Access Compliance Report

Public Rights-of-Way

(Island Curb Cuts)

| Intersection ID: 10025681 | Main Street: EAST_BV | Cross Street: N/A | Location: N |

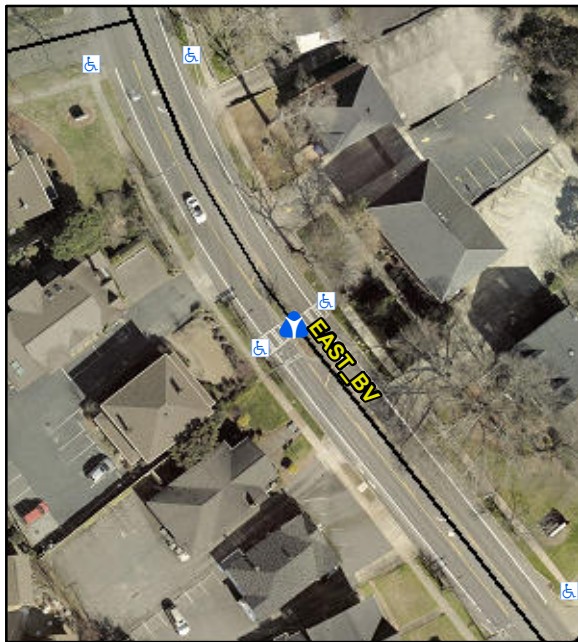
| ADA ID: 713D21928452 | Curb Cut Type: MedianRefuge2 | Initial Pass/Fail: Fail | Overall Compliance: No |

| Compliance | Description | Data | Compliance | Description | Data |
|------------|----------------------|-------|------------|-----------------------------|------|
| No | Refuge 1 Slope (%) | 5.1 | N/A | Gutter 1 Slope (%) | N/A |

Remove & Replace Entire Refuge.
